Access Compliance Report

Public Rights-of-Way

Intersection ID: 26423	Main Street: BEVINGTON_PL	Cross Street: SILVER_PINE_DR	Location: NE
ADA ID: 2C6D89AA78A1	Ramp Type: PerpDiag	Initial Pass/Fail: Fail	Overall Compliance: No
		Severity Score: 37.5

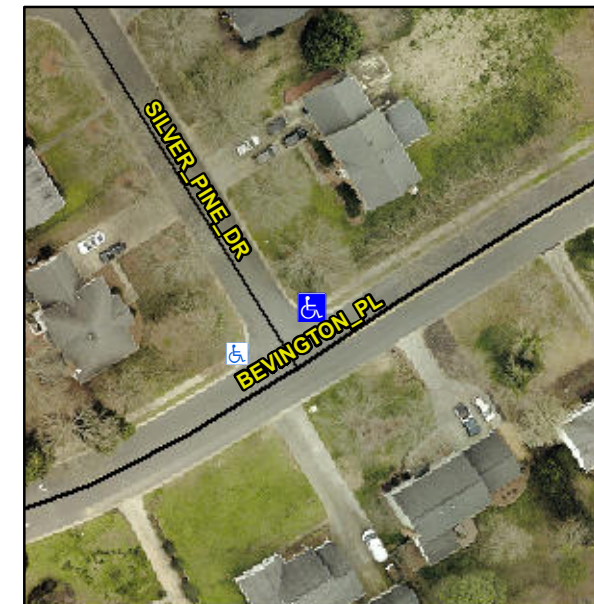
Not Found, R304.2.2, R304.5.3

Compliance	Description	Data	Compliance	Description	Data
N/A	Ramp Length (in)	30.0	No	Ramp Slope (%)	8.8
Yes	Ramp Width (in)	48.0	No	Ramp XSlope (%)	10.1
N/A	Flare Type LT	N/A	N/A	Flare Type RT	N/A
N/A	Flare Slope LT (%)	N/A	N/A	Flare Slope RT (%)	N/A
N/A	Flare Traversable LT?	N/A	N/A	Flare Traversable RT?	N/A
N/A	Landing Length (in)	N/A	N/A	DWS Provided?	N/A
N/A	Landing Width (in)	N/A	N/A	DWS Contrast?	N/A
N/A	Landing Slope (%)	N/A	N/A	DWS Length (in)	N/A
N/A	Landing X Slope (%)	N/A	N/A	DWS Full Width?	N/A
N/A	Landing Curb? (Y/N)	N/A	N/A	DWS Offset (in)	N/A
N/A	Shared Landing?	N/A			
N/A	Gutter Ponding?	N/A	N/A	Gutter Slope (%)	N/A
N/A	Gutter Lip Ht (in)	N/A	N/A	Gutter X Slope (%)	N/A
N/A	Painted X Walk1?	No	N/A	Painted X Walk2?	No
	X Walk 1 Direction	To SW		X Walk 2 Direction	To S
N/A	X Walk 1 Width (in)	N/A	N/A	X Walk 2 Width (in)	N/A
	X Walk 1 Slope (%)	3.2		X Walk 2 Slope (%)	8.0
	X Walk 1 X Slope (%)	5.1		X Walk 2 X Slope (%)	2.8

Remove & Replace Curb Ramp With Two New Directional Ramps or Equivalent.
